# Work Order ID 89017

Item Name: Crosstube Fwd

Reference: NCR 12-1695

# DART SERVICE INSTRUCTION

**FIGURE 1 - GROUNDING STRAP INSTALLATION**  
(VIEW LOOKING FWD)

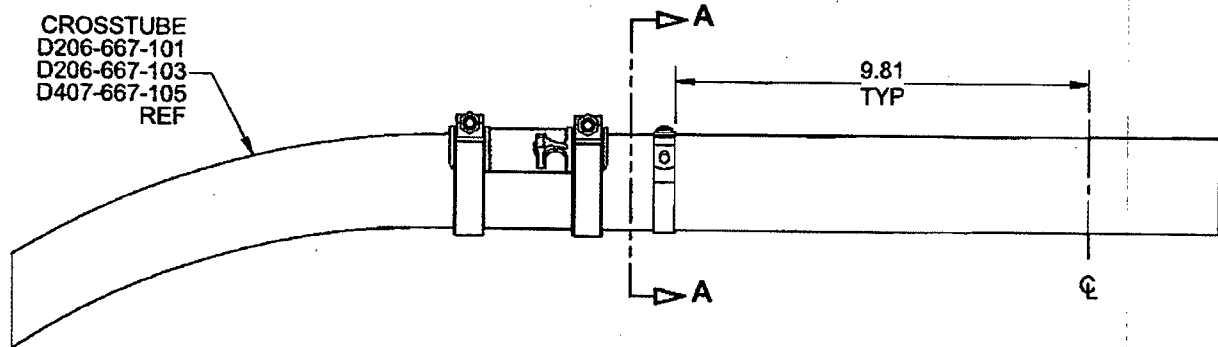
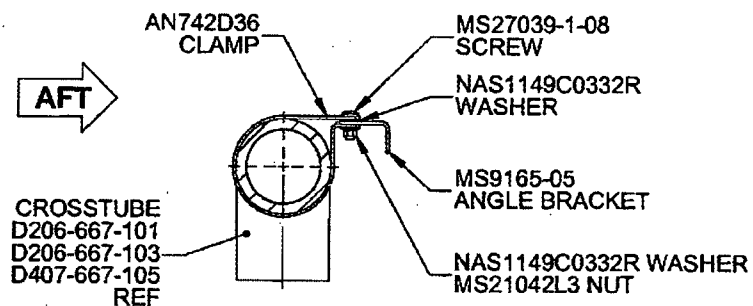
The purpose of this service instruction is to add the optional D206-667-017 Kit and provide guidelines to install extra clamps on D206-667-101/-103 or D407-667-105 forward crosstubes to allow fastening of OEM grounding straps.

- 1) If installed, follow Section 32.1 of ICA-D206-667 for removal of the forward crosstube from the helicopter.
- 2) Locate AN742D36 Clamp as shown in Figure 1 of this service instruction and mark location of clamp on the crosstube.

- 4) Install AN742D36 Clamp complete with MS9165-05 per Section A-A of Figure 1 of this service instruction.
- 5) Touch up paint as required per Item 5.3.3 of ICA-D206-667.

- 6) Seal edges where AN742D36 Clamp meets with crosstube using Sikaflex-241/291 or MIL-S-8802 Class B2 or Proseal 890 sealant.
- 7) Install/re-install forward crosstube in accordance with Section 32.2 of ICA-D206-667.

- 8) Fasten OEM grounding strap to MS9165-05 Angle Bracket on forward crosstube per Bell instructions.
- 9) Undertake a resistance check between a ground point on the skidtube and aircraft ground in accordance with Class R-II requirement per BHT-ELEC-SPM. Maximum resistance is 10 milliohms (mΩ).
